Production Discontinuation of Relay Terminal Modules and Their Dedicated Connection Cables

A6TE2-16SRN, AC06TE, AC10TE, AC30TE, AC50TE, AC100TE

FA-A-0410-A

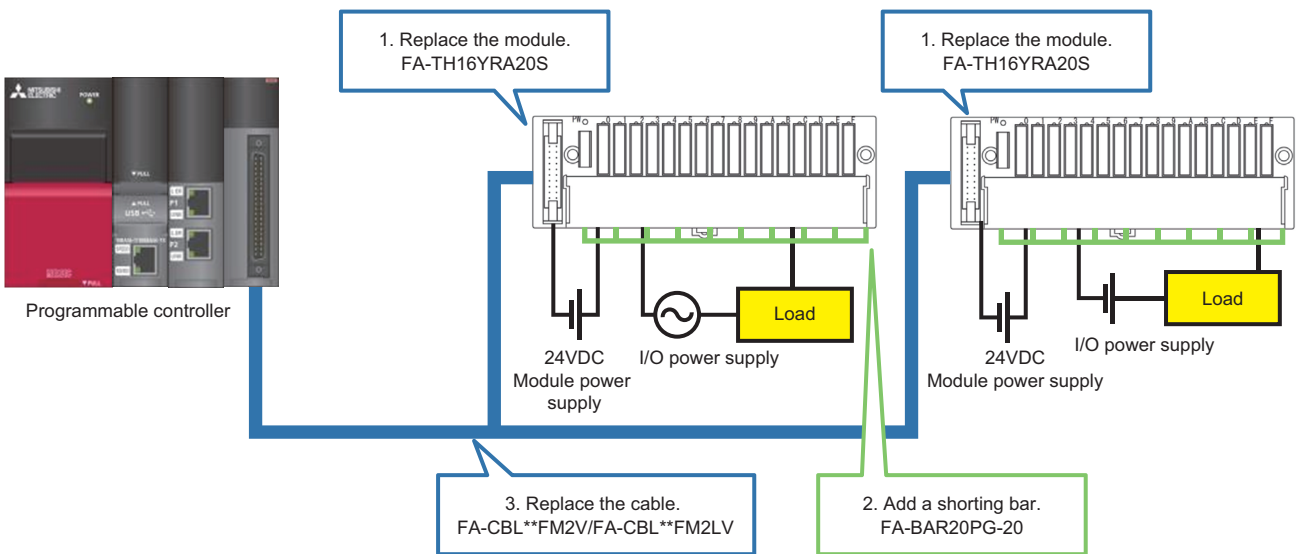
Item	Model to be discontinued: A6TE2-16SRN	Alternative model: FA-TH16YRA20S	Restrictions
External dimensions	Height: 69.5mm Width: 180mm Depth: 56.3mm	Height: 57mm Width: 160mm Depth: 41.5mm	There is not much difference. (miniaturized)
Rated switching voltage/current	24VDC, 2A (resistance load) 240VAC, 2A (COS ϕ = 1)/1 contact, 8A/common	24VDC, 2A (resistance load) 200VAC, 2A (COS ϕ = 1)/1 contact, Independent common ^{*1}	There is not much difference. ^{*1*2}
Maximum switching voltage	264VAC 125VDC	270VAC 150VDC	
Maximum switching frequency	3600 times/hour	1800 times/hour	Use the model under the condition of being on/off for 1 second or longer. There is a restriction on the switching frequency, however, there is no change in the guaranteed value of the number of switching times (electrical service life).
Wiring method for common	16-point output 8 points/1 common	16-point output 16-point independent common	To continue using the present wiring, a shorting bar of FA goods for the M3 screw terminal block (FA-BAR20PG-20) is required. (Page 3 REPLACEMENT PROCEDURE)

Installation direction	Vertically in three directions, horizontally in one direction (Do not install the module upside down.)	Vertically in three directions (Do not install the module horizontally or upside down.)	If the module is installed horizontally, foreign matter may enter and cause malfunction. Install it vertically in three directions.

*1 Because the wiring method for common is different, a shorting bar is required. (Page 3 REPLACEMENT PROCEDURE)

*2 The rated switching voltage is changed from 240VAC to 200VAC, however, there is no problem in using the current I/O power supply because the maximum switching voltage is 270V.

1. Replace the A6TE2-16SRN with the FA-TH16YRA20S.
2. Add the shorting bar FA-BAR20PG-20 to the FA-TH16YRA20S.
3. Replace the connection cable AC**TE with the FA-CBL**FM2V or FA-CBL**FM2LV. The available output module differs depending on the shape of connector on the programmable controller side. To select a connection cable, refer to Page 3 SELECTION OF DEDICATED CONNECTION CABLE FOR TERMINAL MODULES.
